Novus Build to Rent 39-43 Hassall Street, Parramatta

City of Parramatta Council
Presentation to Independent Planning Commission

1% AEP Flood Hazard H3-H4

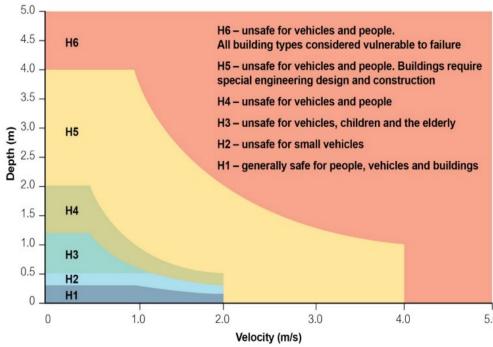
According to the Council's Draft Flood Study the entire site is flooded with H3 to H4 flood hazards. This information has been available on Councils website. In the Applicant's proposal the 1% AEP flood hazard has been shown only H1 to H2.

APPLICANT'S GROUND FLOOR PLAN Inactive facade Active facade

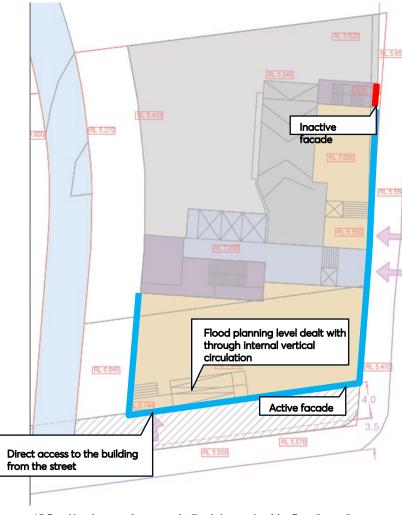
DESIGN PRINCIPLES		DESIGN EVALUATION
Establish a pattern of contextually-scaled 4-6 storey street wall podiums with active street frontages.		
P.01	In streets with active ground floor frontages, the development model for the city is for the lower 4-6 storeys to collectively define and articulate the spaces of the public domain, with towers set back as clearly distinct free-standing buildings	
O.04	Recognise the variation in street frontage heights throughout the city and allow flexibility to respond to context.	
C.01 b	The street wall must be built to the street boundary a minimum of 14 metres and a maximum of 21 metres above the footpath level.	
C.01 c	The tower above the street wall must be set back a minimum of 6 metres from the street boundary wall.	
N	ot supported Supported

Raised platform and irregular

building alignment separates the ground floor from the street

STREET WALL OF THE PROPOSED DESIGN

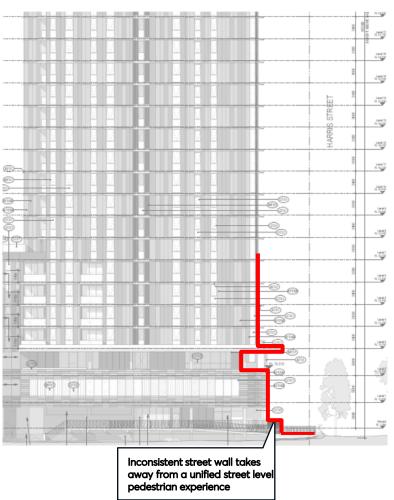
DESIGN PRINCIPLES		DESIGN EVALUATION
Establish a pattern of contextually-scaled 4-6 storey street wall podiums with active street frontages.		
P.01	In streets with active ground floor frontages, the development model for the city is for the lower 4-6 storeys to collectively define and articulate the spaces of the public domain, with towers set back as clearly distinct free-standing buildings	
O.04	Recognise the variation in street frontage heights throughout the city and allow flexibility to respond to context.	
C.01 b	The street wall must be built to the street boundary a minimum of 14 metres and a maximum of 21 metres above the footpath level.	
C.01 c	The tower above the street wall must be set back a minimum of 6 metres from the street boundary wall.	
N	ot supported Supported

COUNCIL PREFERRED STREET WALL

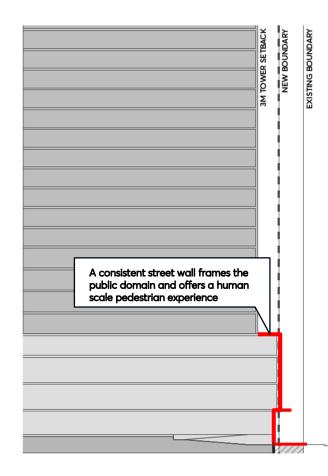
DESIGN PRINCIPLES		DESIGN EVALUATION	
	Establish a pattern of contextually-scaled 4-6 storey street wall podiums with active street frontages.		
P.01	In streets with active ground floor frontages, the development model for the city is for the lower 4-6 storeys to collectively define and articulate the spaces of the public domain, with towers set back as clearly distinct free-standing buildings		
O.04	Recognise the variation in street frontage heights throughout the city and allow flexibility to respond to context.		
C.01 b	The street wall must be built to the street boundary a minimum of 14 metres and a maximum of 21 metres above the footpath level.		
C.01 c	The tower above the street wall must be set back a minimum of 6 metres from the street boundary wall.		
N	ot supported Supported

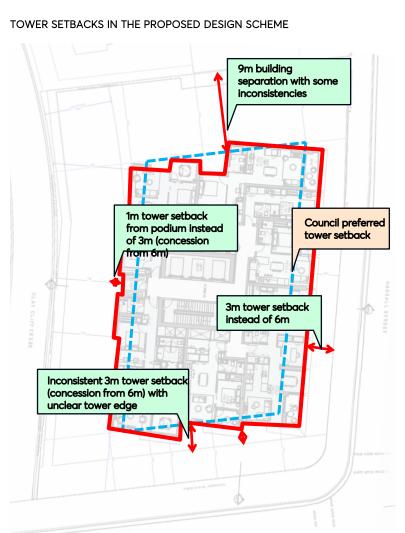
UNCLEAR TOWER SETBACKS

DESIGN	PRINCIPLES	DESIGN EVALUATION
Visually separate towers from podiums though adequate upper-level setbacks.		
C.01 c	The tower above the street wall must be set back a minimum of 6 metres from the street boundary wall.	
C.03	Development must provide a minimum 6 metre tower setback to support views to sky from a creek corridor and natural daylighting to deep soil and vegetation.	
P.03	Towers are set back above street walls to reinforce the scale of the streets, mitigate wind and urban heat impacts, enable views to the sky and protect amenity in streets and public places.	
N	ot supported Supported

COUNCIL PREFERRED STREET WALL

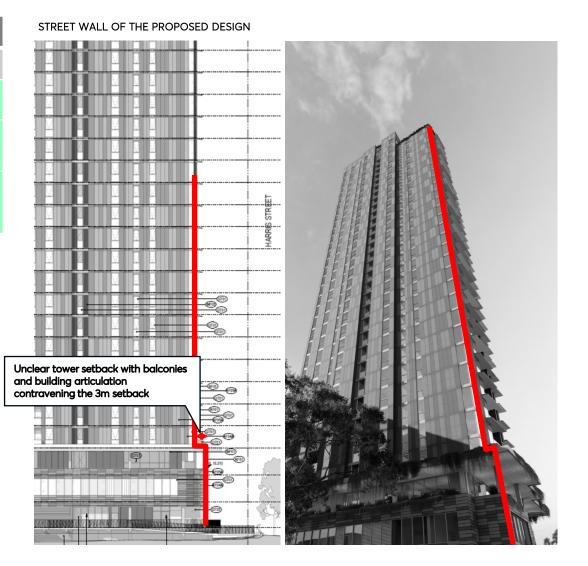
DESIGN PRINCIPLES		DESIGN EVALUATION
Visually separate towers from podiums though adequate upper-level setbacks.		
C.01 c	The tower above the street wall must be set back a minimum of 6 metres from the street boundary wall.	
C.03	Development must provide a minimum 6 metre tower setback to support views to sky from a creek corridor and natural daylighting to deep soil and vegetation.	
P.03	Towers are set back above street walls to reinforce the scale of the streets, mitigate wind and urban heat impacts, enable views to the sky and protect amenity in streets and public places.	
N	ot supported Supported

A clear 3m tower setback (concession from 6m). All articulation of the tower form is behind this setback.

BASEMENT ENCROACHING CREEK CORRIDOR

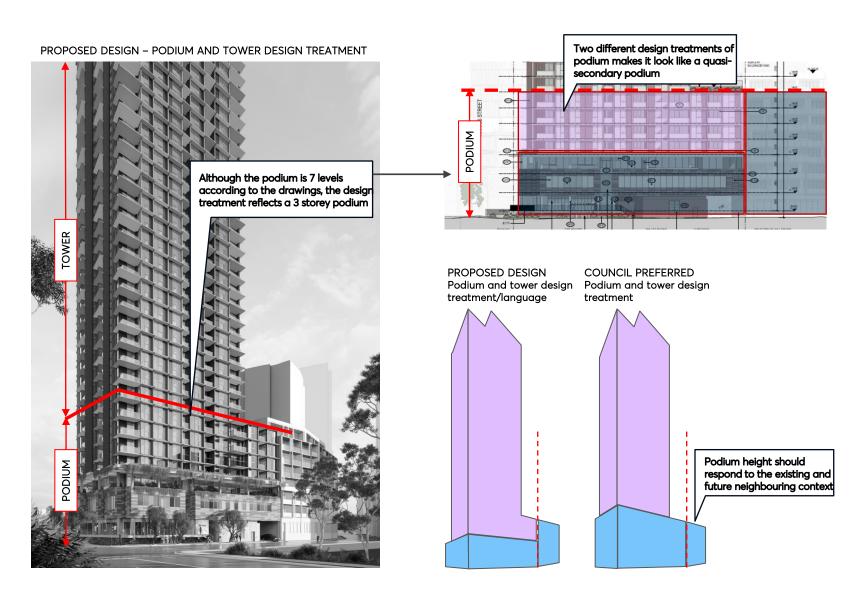
DESIGN PRINCIPLES		DESIGN EVALUATION
Establish Clay Cliff Creek as a deep soil green corridor with WSUD, views to sky and daylight.		
	Establish Clay Cliff Creek and other tributaries of the Parramatta River as priority green corridors for ecological protection, flood sensitive strategies and future landscape improvements.	
	Utilise a deep soil setback zone to create a contiguous landscape along creek corridors with the intention of leaving space for a publicly accessible movement corridor in the future.	
C.03	Development must provide a minimum 6 metre tower setback to support views to sky from a creek corridor and natural daylighting to deep soil and vegetation.	
	Not supported Supported
